Date : 09/10/2017		Material : Metal, finish	Weight: 0.025-0.050 Kg	Draw by : mjupille
Scale: 1:5	Page: 1 / 2	Title : CEILING CUP FOR DCL		
		COREP		
Document n° : 01			Revision. :

Date : 09/10/2017		Material : Metal, finish	Weight: 0.025-0.050 Kg	Draw by : mjupille
Scale: 1:2	Page: 2 / 2	Title : CEILING CUP FOR DCL		
		COREP		
Solid Edge SIEMENS PLM Software		Document n° : 01		Revision. :

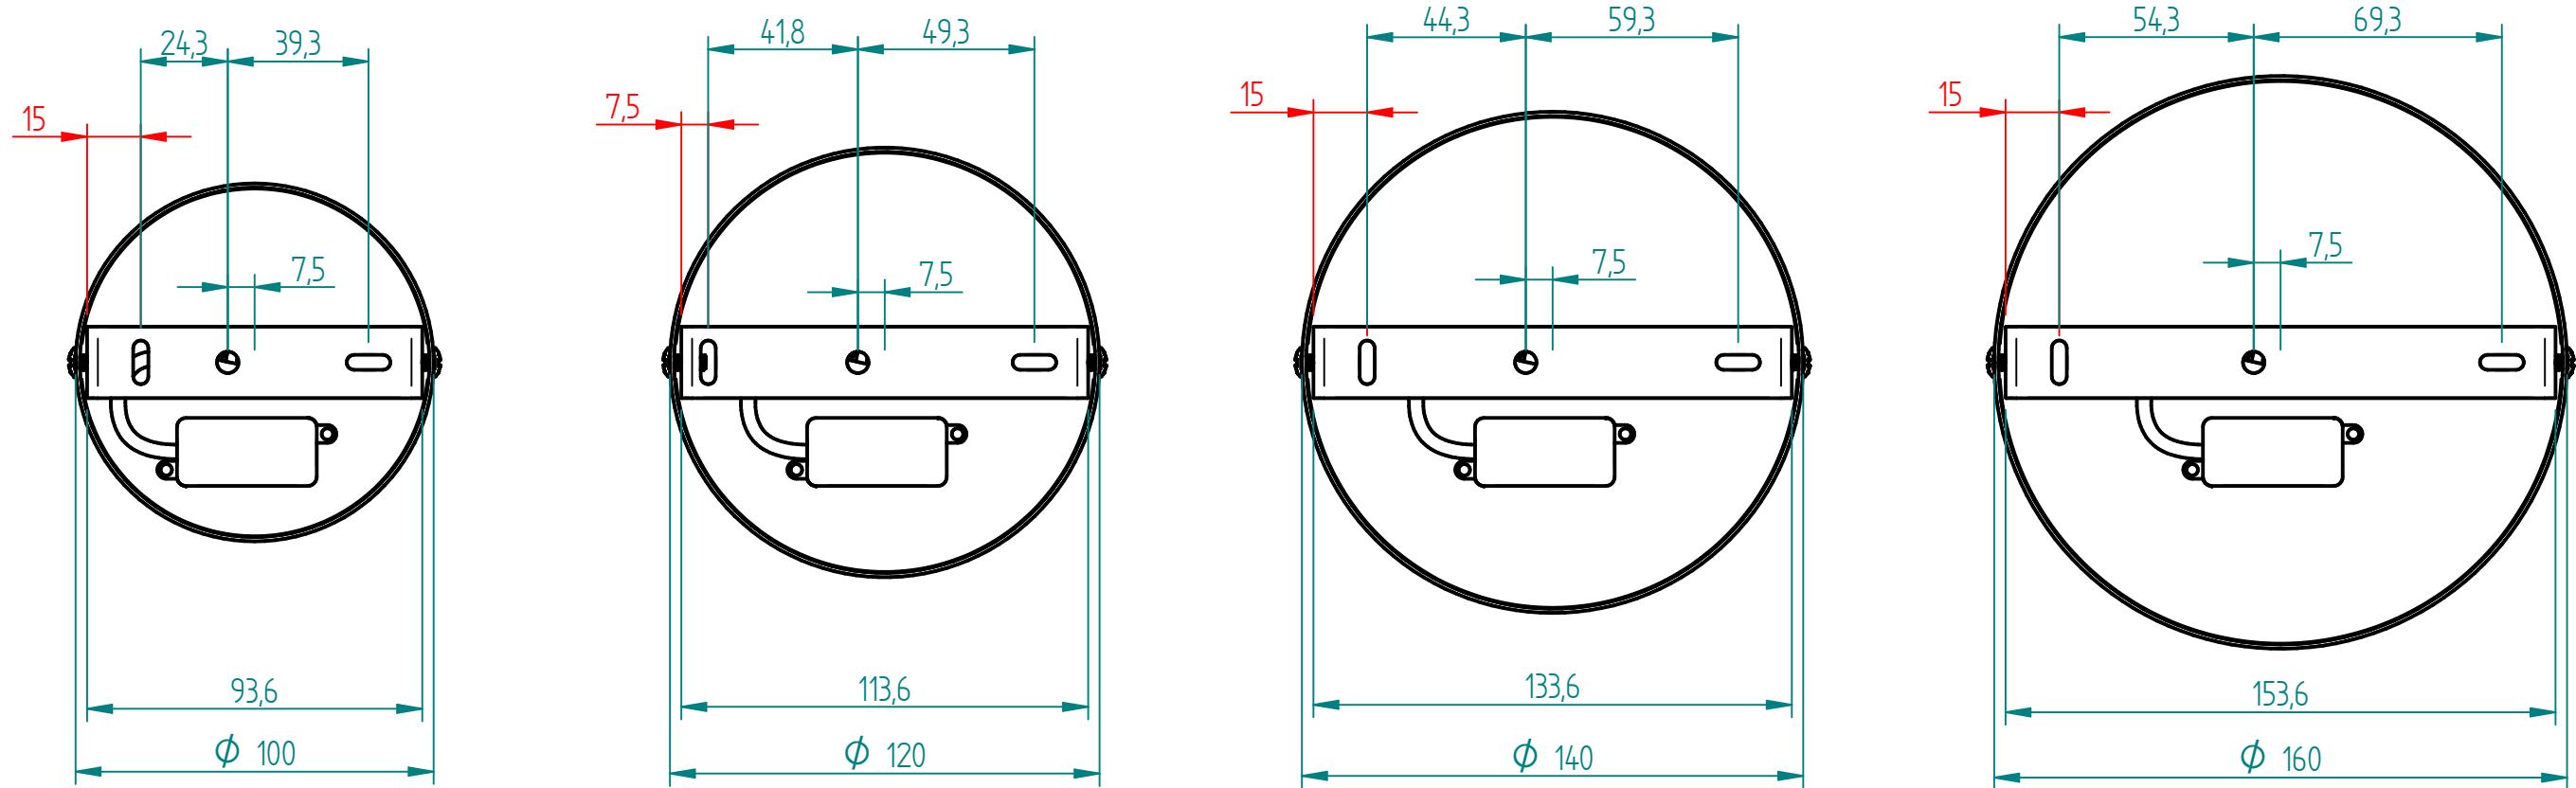
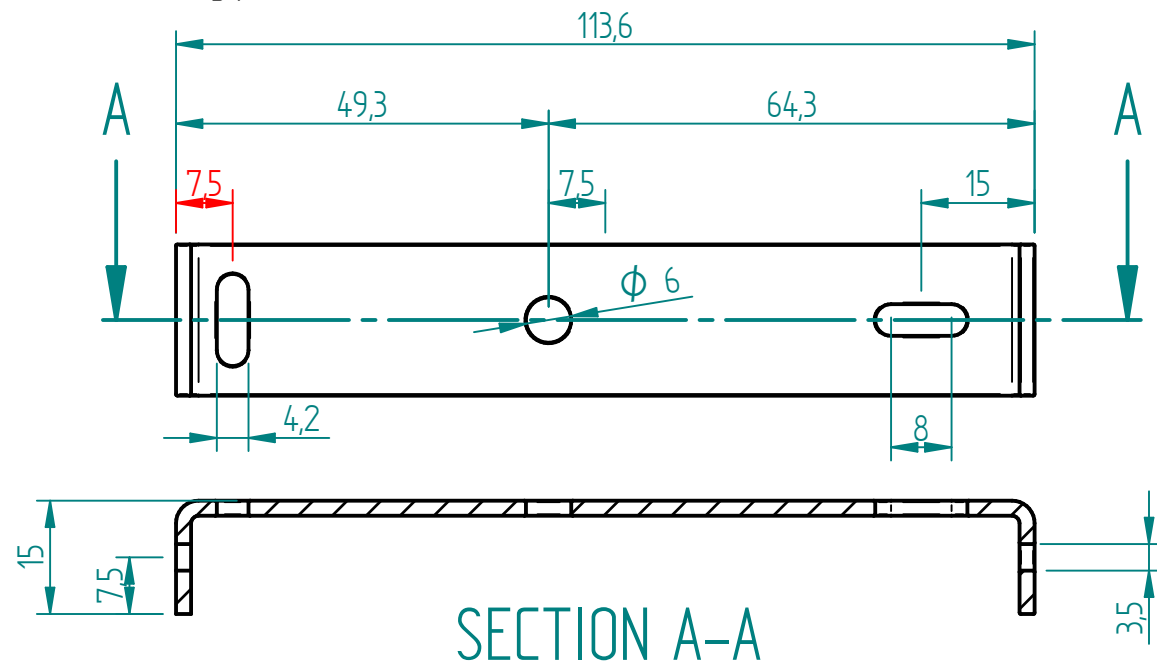
For $\varnothing > 100$ mm and $\varnothing < 140$ mm (like 120mm),
the lenght in red is 7.5 and not 15

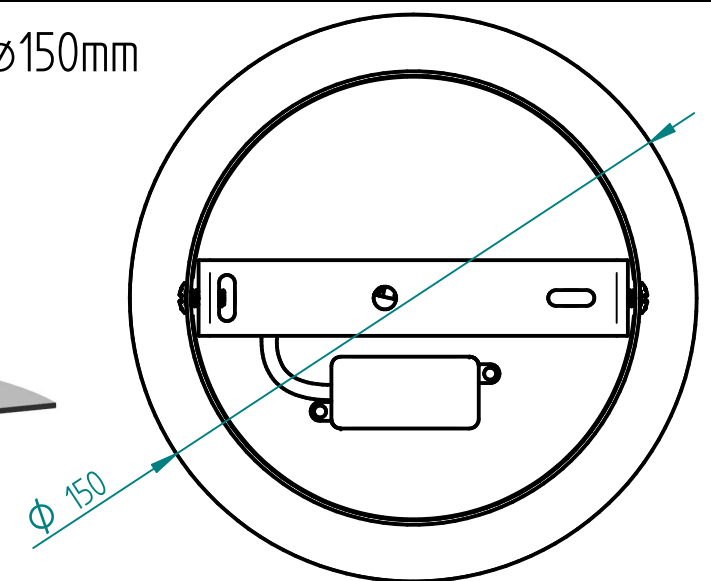
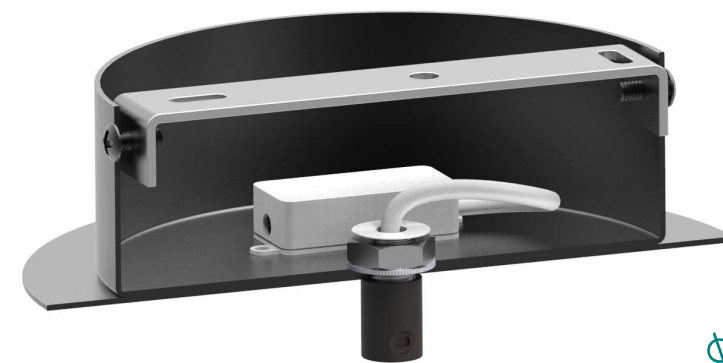
Same height for standard DCL CEILING CUP, for any diameter
Only change if we ask for another height

Exemple for the ceiling plate for $\varnothing 120$ mm

Exemple for ceiling cup with cover $\varnothing 150$ mm

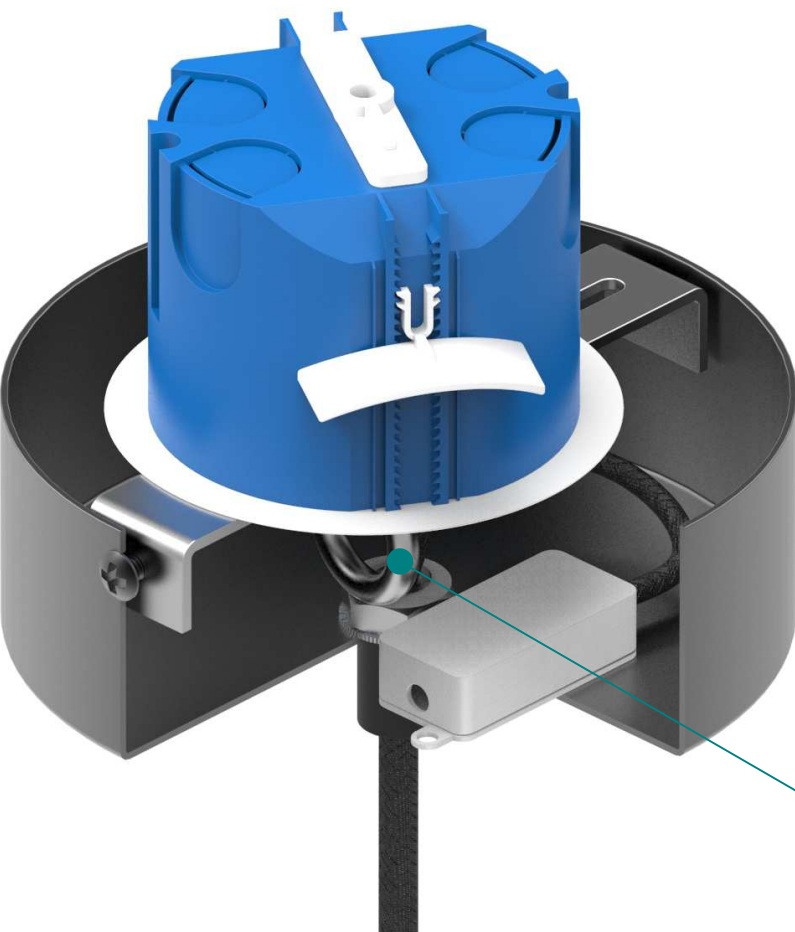
Same dimensions for class 1 and class 2

Hole in all ceiling plate. The hole is not centered, it is at 7.5 mm from the center of the plate

The hole is used to fix the cup to the ceiling with a hook (new french certification)
